**86130A-10**

# S E R V I C E N O T E

## 86130A BitAlyzer Error Performance Analyzer

**Disable power supply 'Fan Stop' alarm to prevent output amps from being disabled.**

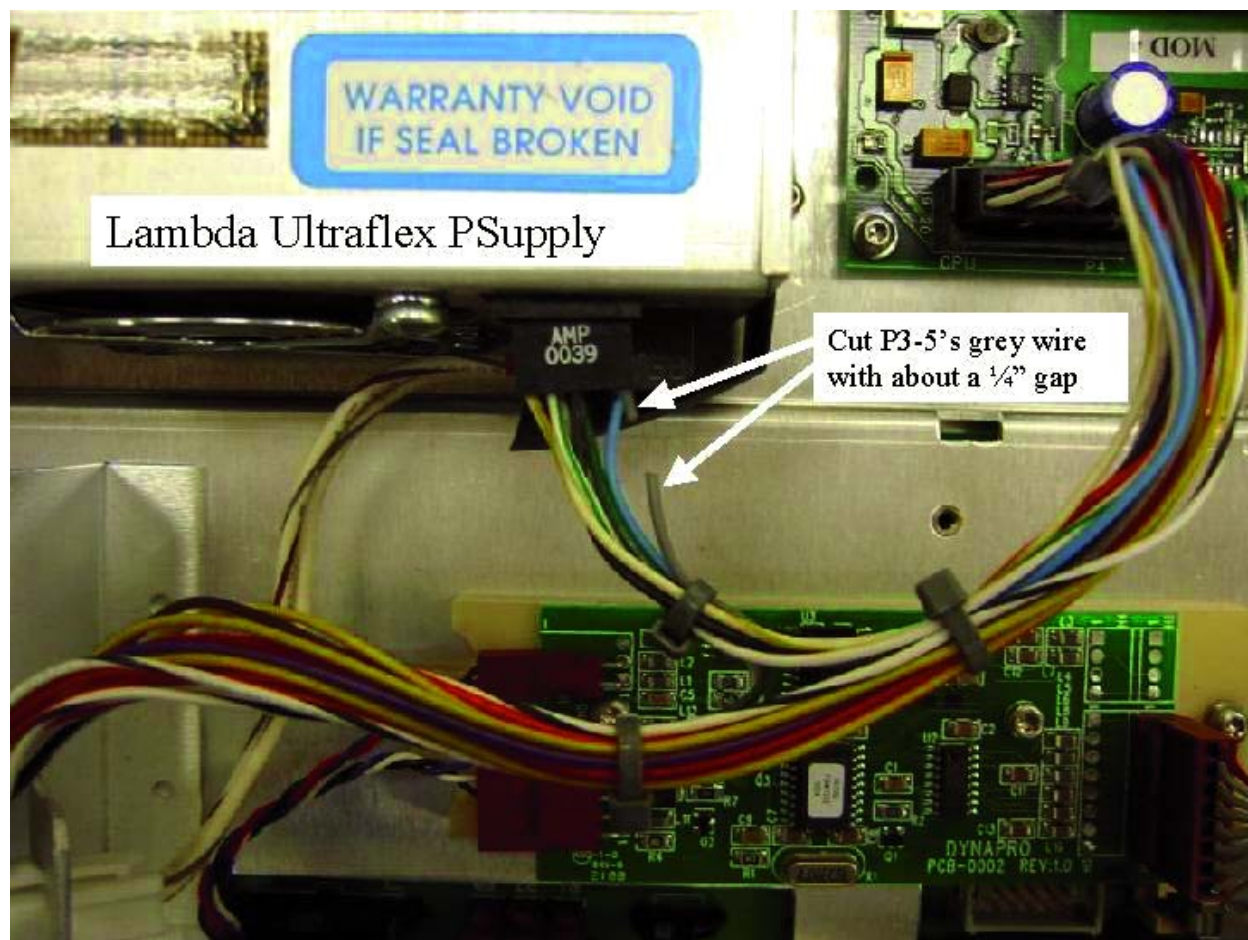
A power supply fan that sticks during startup can cause a shutdown signal that disables the output amplifiers on the Pattern Generator assembly (A2). All four output amps (Data, DataBar, Clock, and ClockBar) will be prevented from functioning if this occurs. (See also SN86130A-06A for similar symptoms).

Although the power supply fan will operate normally after a few seconds, it may be slow to startup causing the power supply FAN/Thermal shutdown signal to be sent. Depending on when it occurs during bootup, it may be logged as a Category 200 event in the NT Event Viewer.

Disable the power supply FAN STOP shutdown signal.

1. Locate J3 on the power supply (A1A1) assembly.
2. Cut J3-5 (GREY wire) between the J3 connector the harness tie wrap. The cut should leave approximately ¼" of wire protruding out of the power supply. See photo below (P3=J3).

**Note:** Both the PFW and Fan/Thermal outputs are open collector, and wire-or'ed together on the Power Supply Distribution board (A1A2, 86130-60001). If the GREY wire (Fan/Thermal) is cut and the proper PLD code is in place, the 86130A will only respond to valid power fail warnings (PFW's – refer to SN86130A-06A).

3. Apply heat shrink tubing to the ends of the cut wire.
  4. Affix Service Note label 86130A-10 to the rear of the instrument near the serial# tag.
- End.
